ADDENDUM 01 – 04.20.2018

Saline Courthouse Restoration

Bid ID: 16932

**GRADING/LAYOUT
 PLAN**

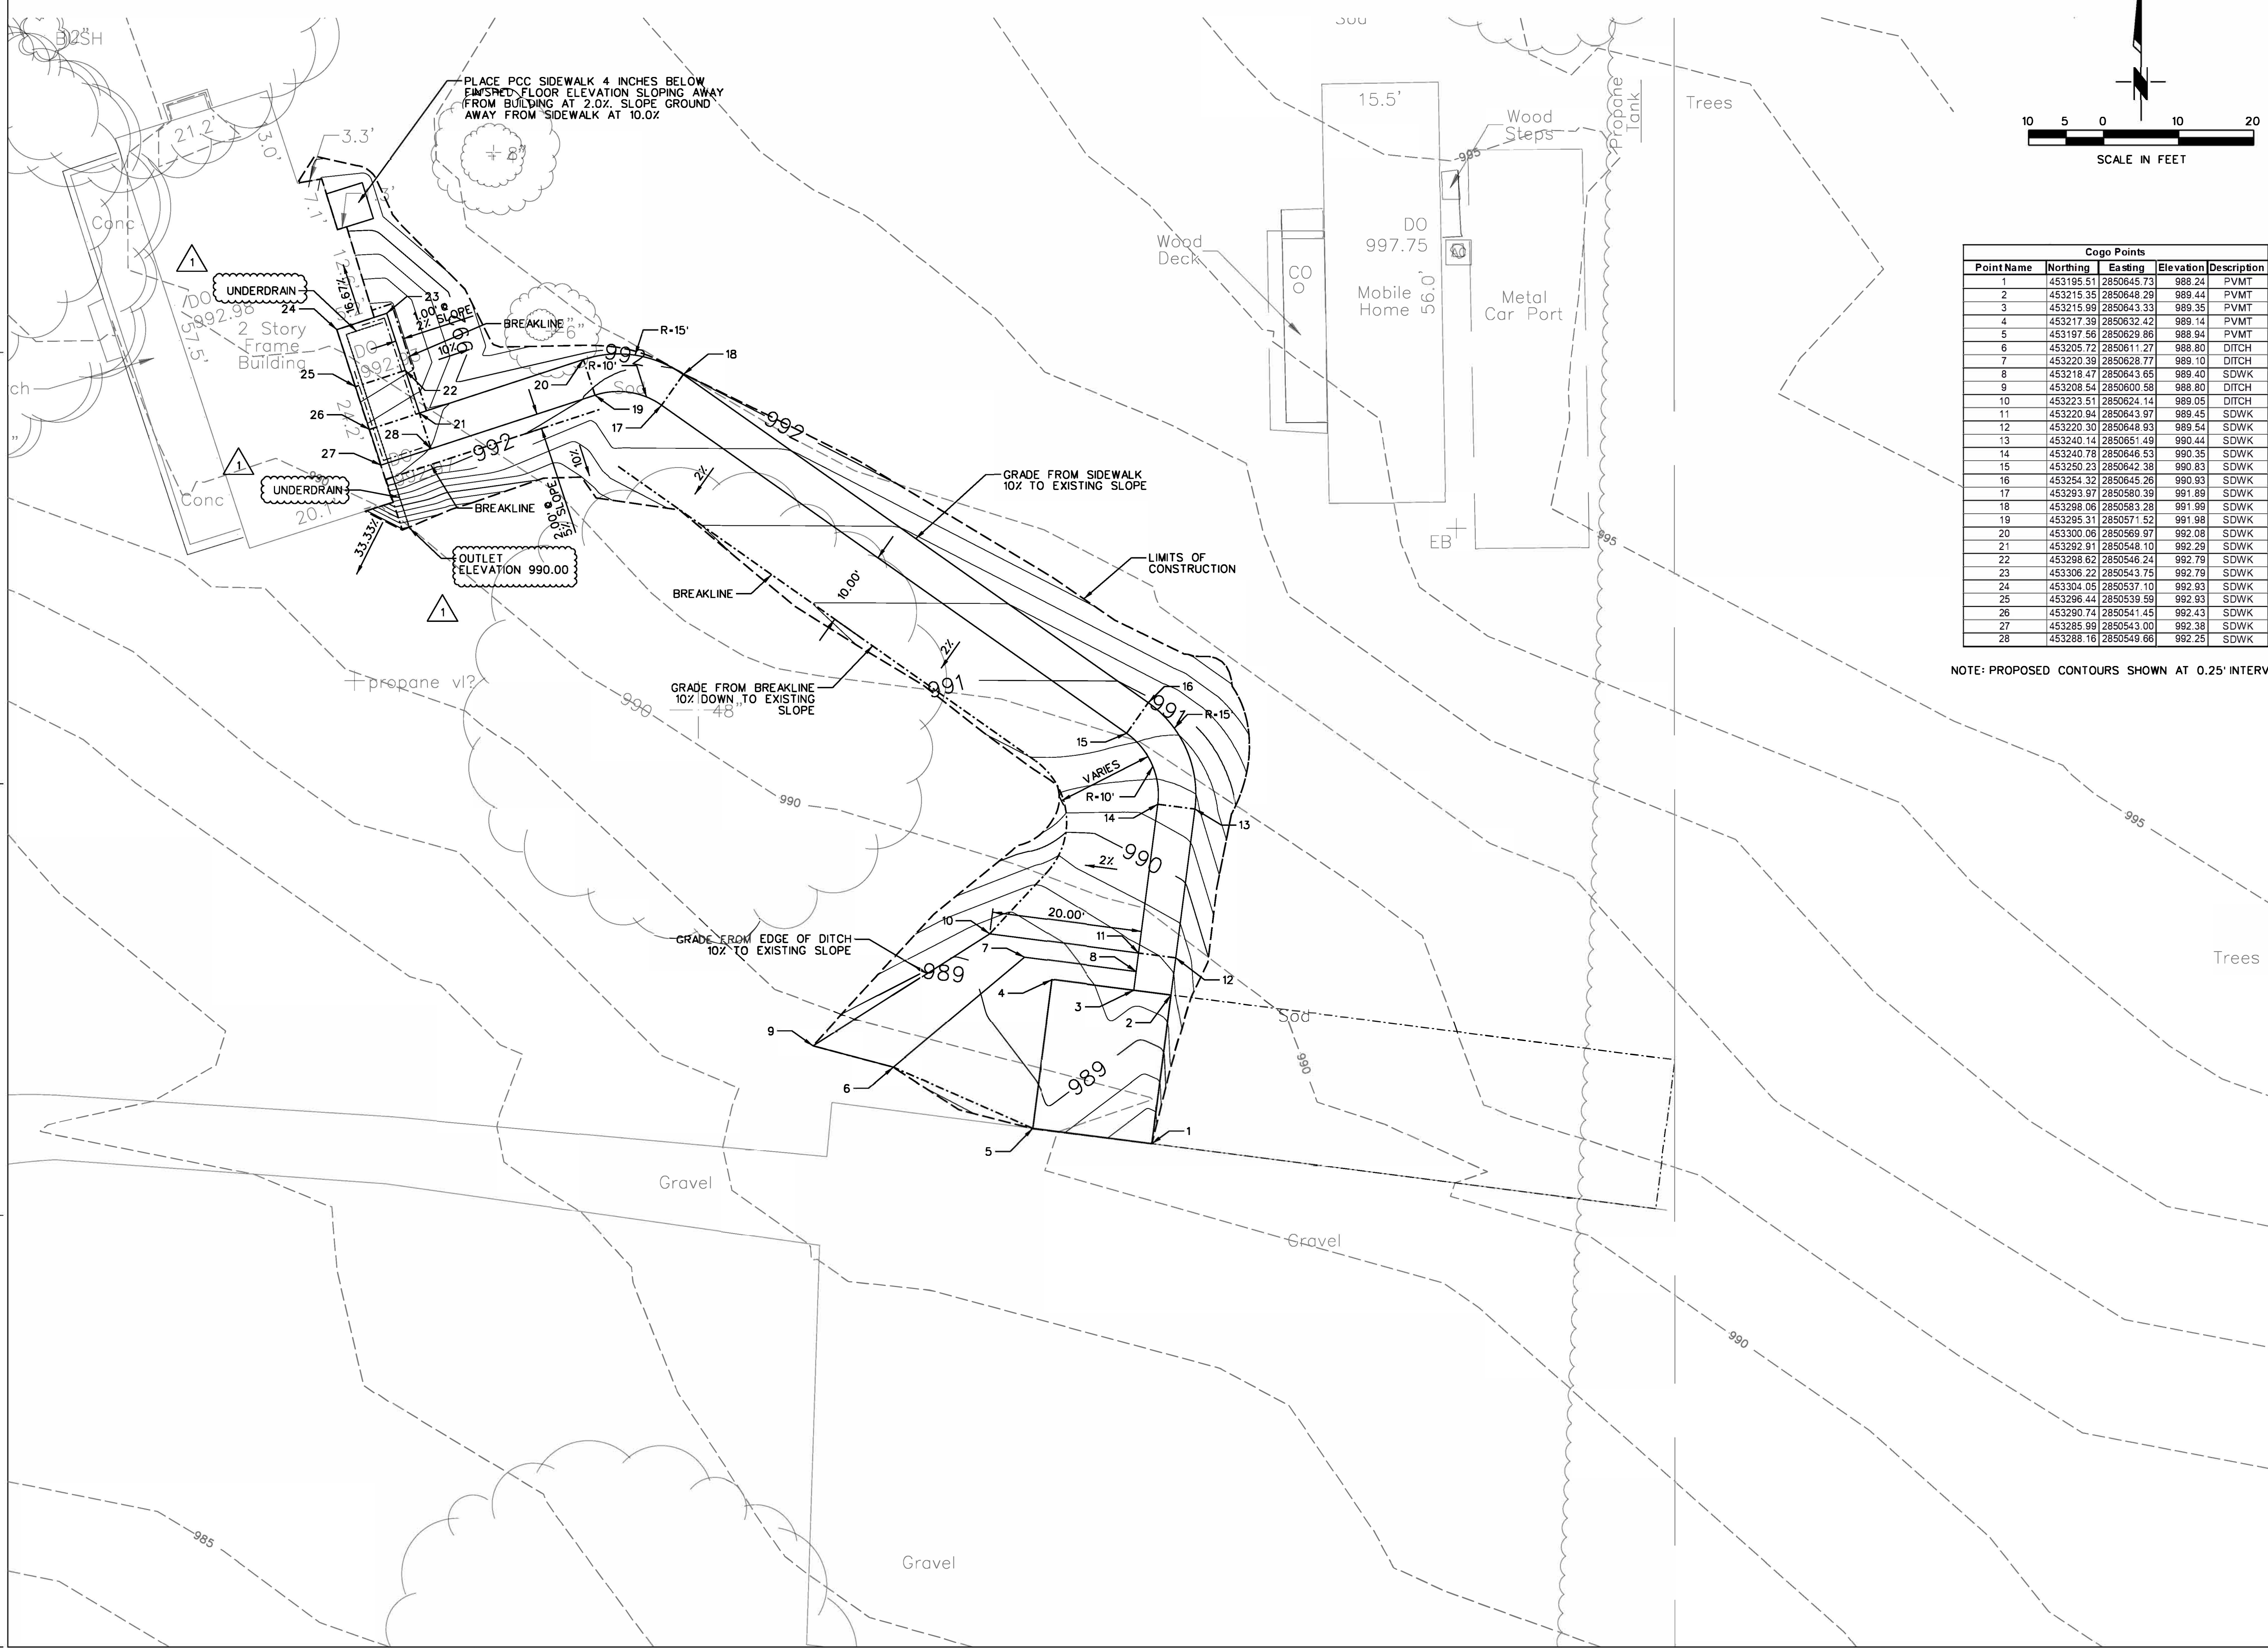
SHEET C300 – Grading/Layout Plan

2. Add additional notes for underdrain.

Answer: See additional information added to Addendum #1 Sheet C300.
18. **Question:** Is GC required to include all onsite soils and concrete testing? or will this service be by the Owner?

1 FLOOR PLAN - LEVEL 1
1/4" = 1'-0"

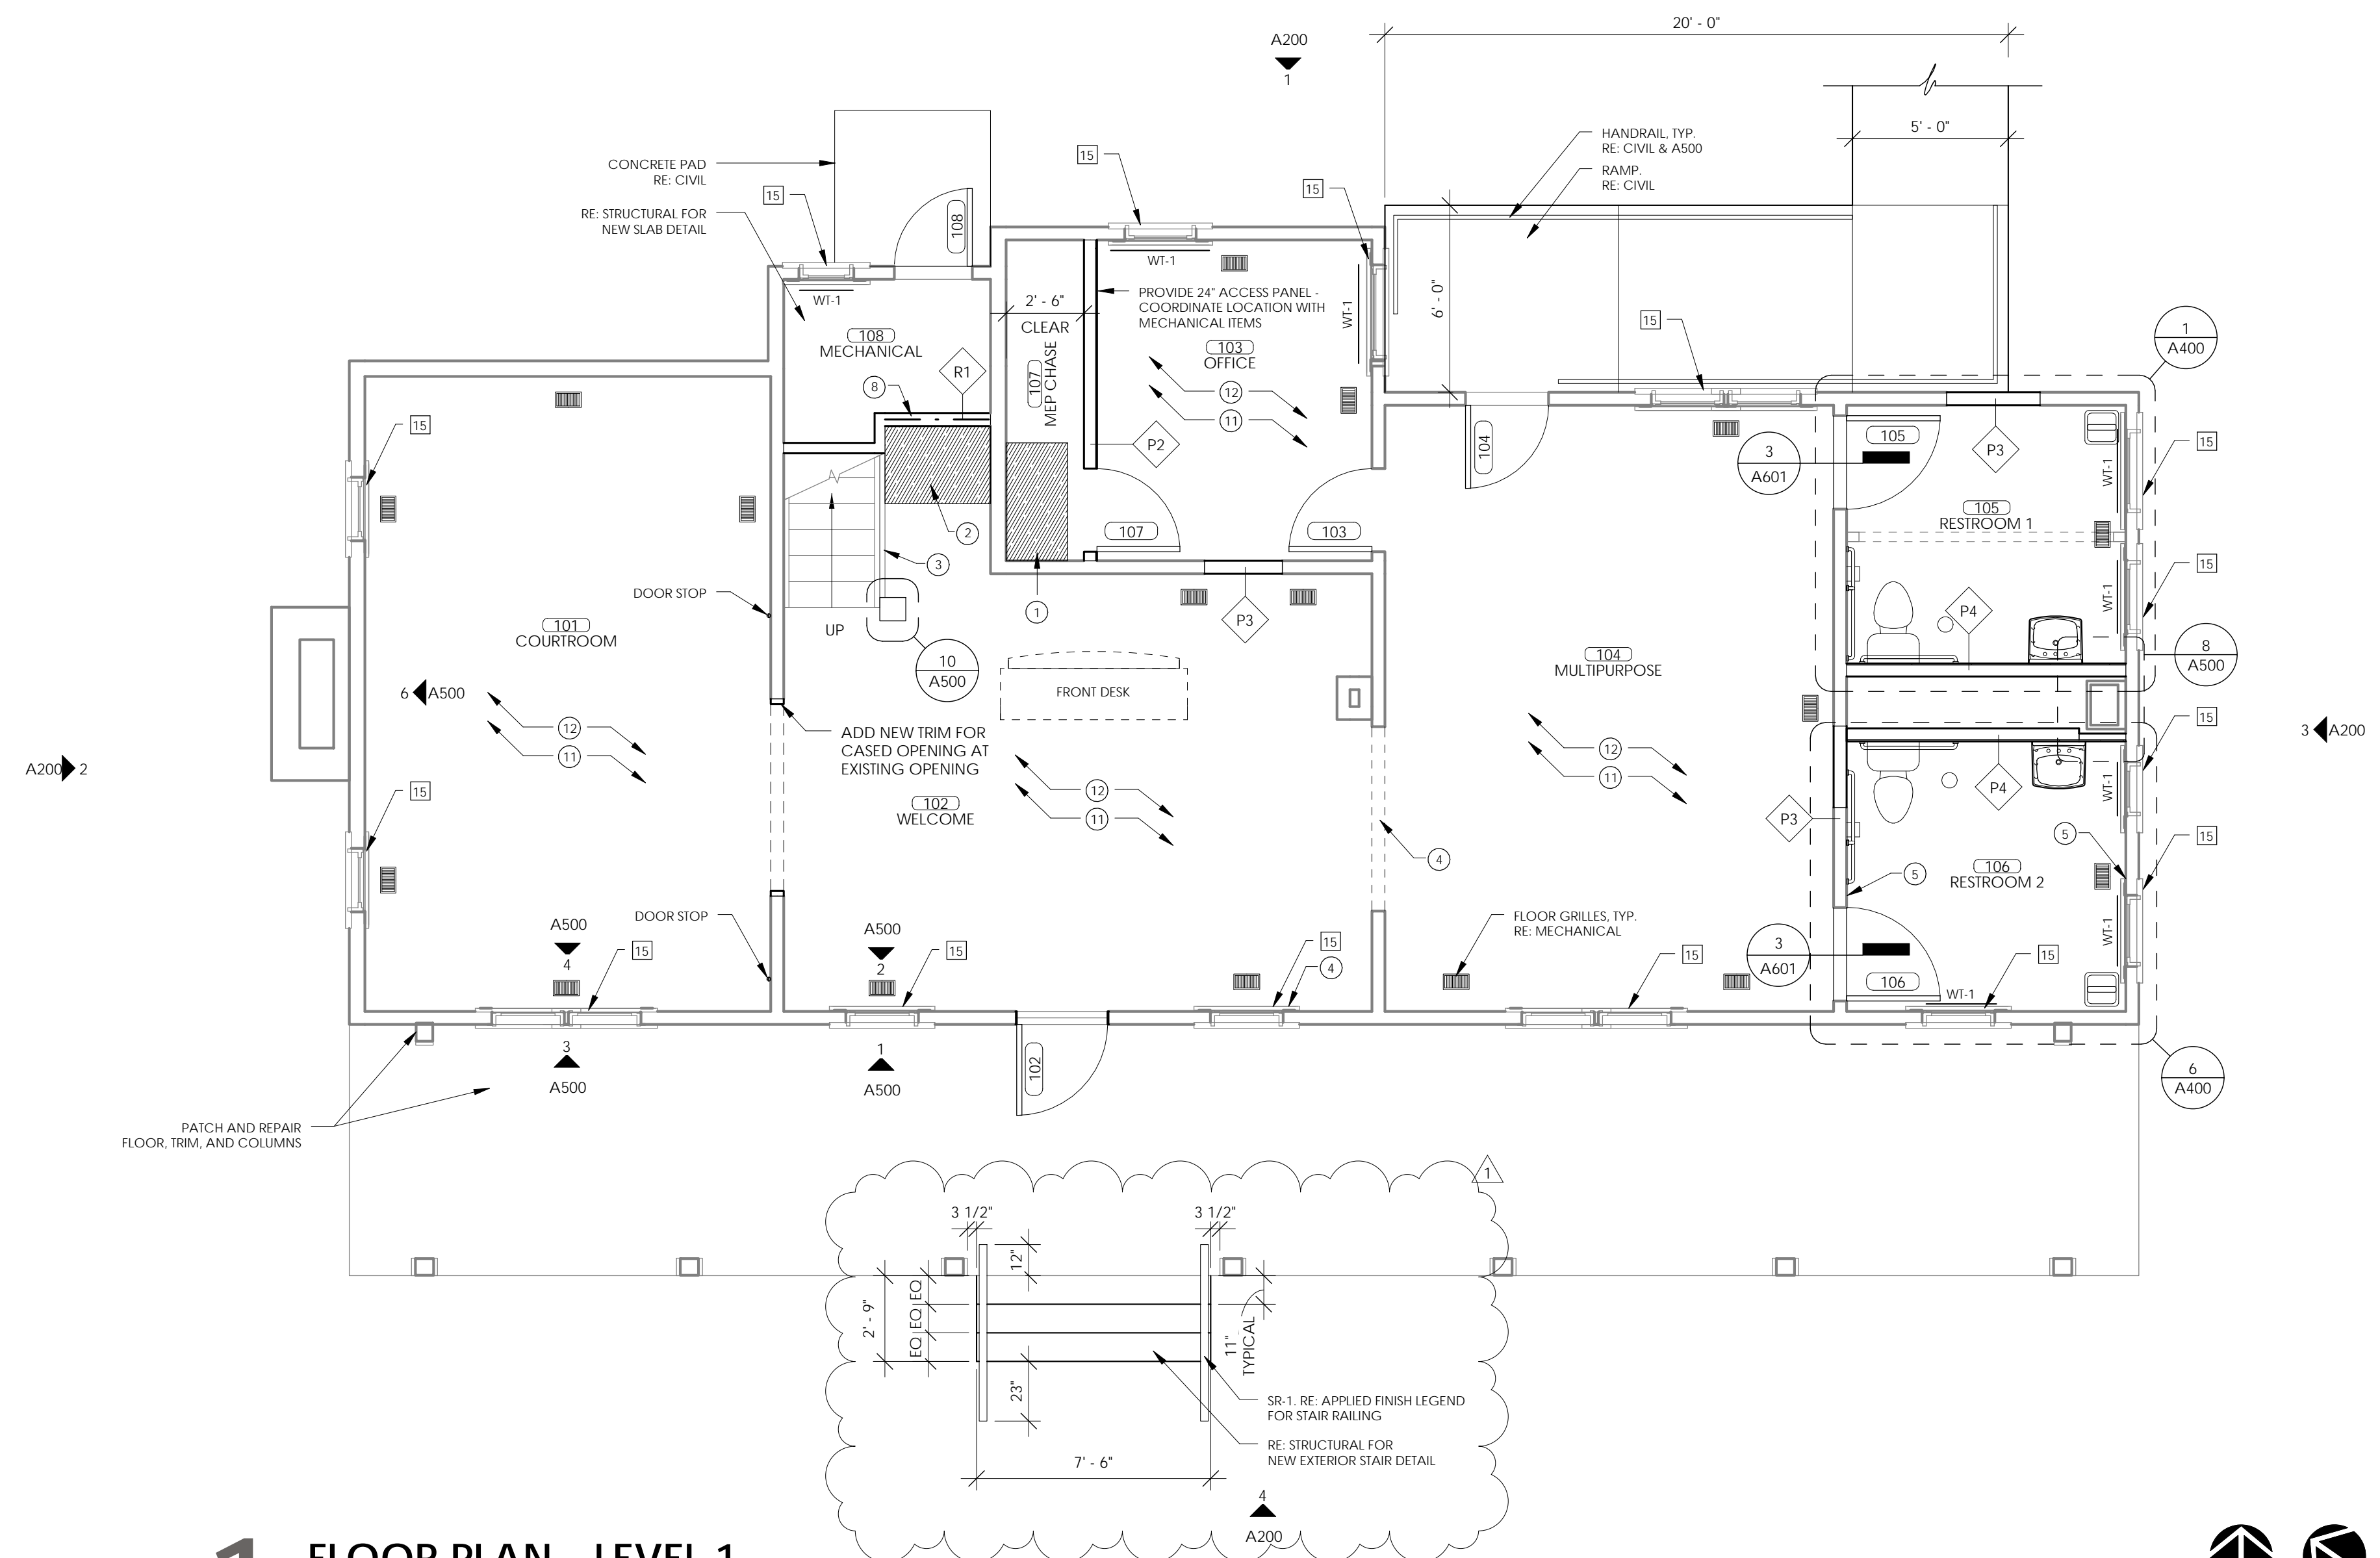
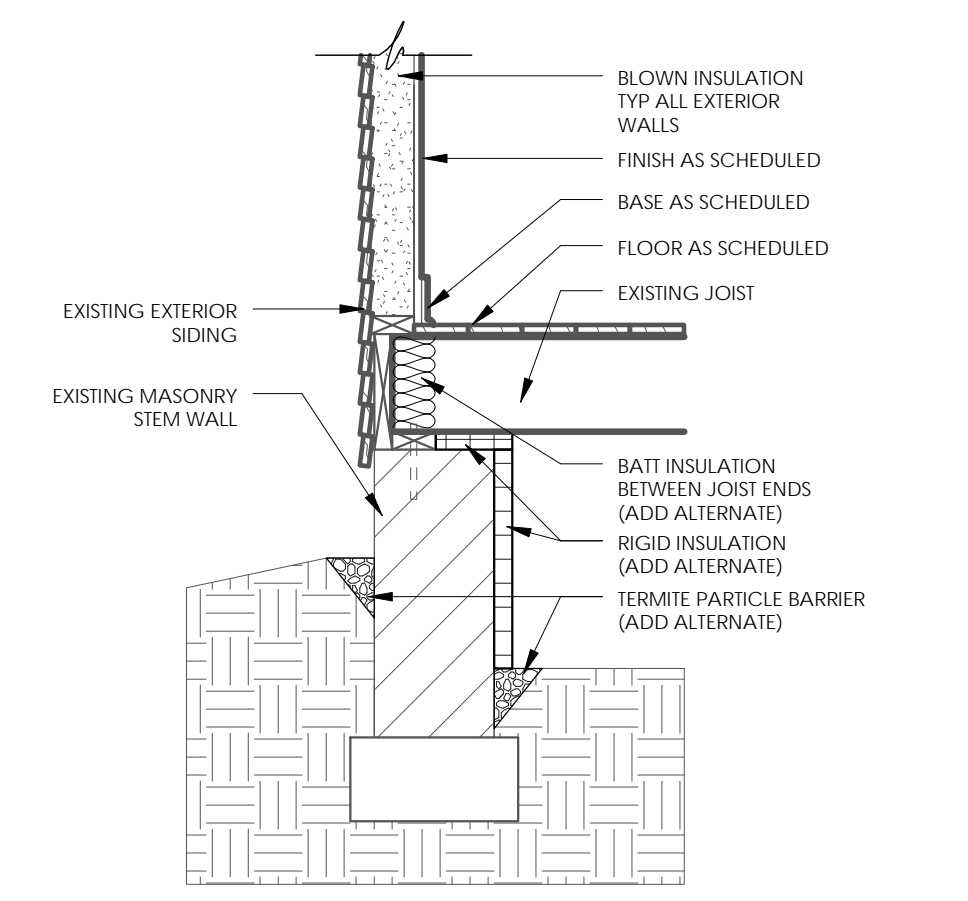
SHEET A101 – Floor Plan – Level 1

3. Revise stair dimensions and handrail extensions lengths.

Answer: Superior Aluminum Products Stock Railing and Series 9000 are approved. Railing will need to extend beyond top and bottom stair treads to meet ADA requirements. See Addendum #1 Sheet A101.

2 INSULATION DETAIL (ALT 3)
3/4" = 1'-0"

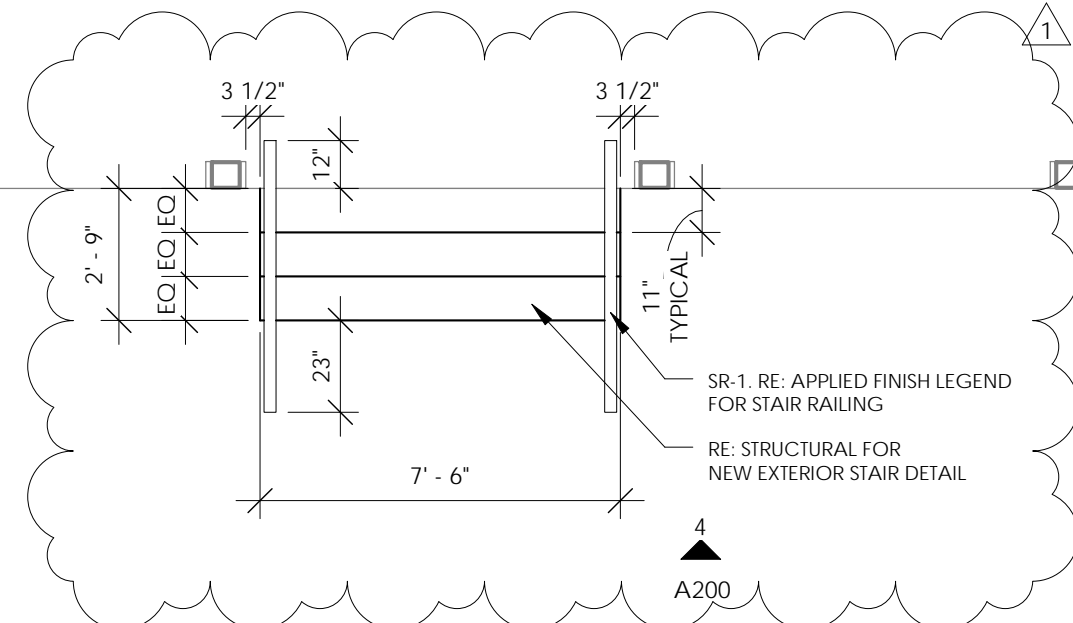
10. **Question:** Detail 2 on A101 shows rigid insulation applied to the inside of the stem walls. It indicates a neat formed concrete stem wall. In fact the stem walls are rough stone and the rigid insulation cannot be applied to that surface. How do you want this work performed?

Answer: Insulation may be held against the surface of the wall with 1"-4" zinc-plated corner braces attached to the bottom sides of the joists, and held at the ground with either galvanized landscape staples or stakes. Additionally, closed cell spray foam insulation may be used in place of the rigid and batt insulation in the crawl space location.
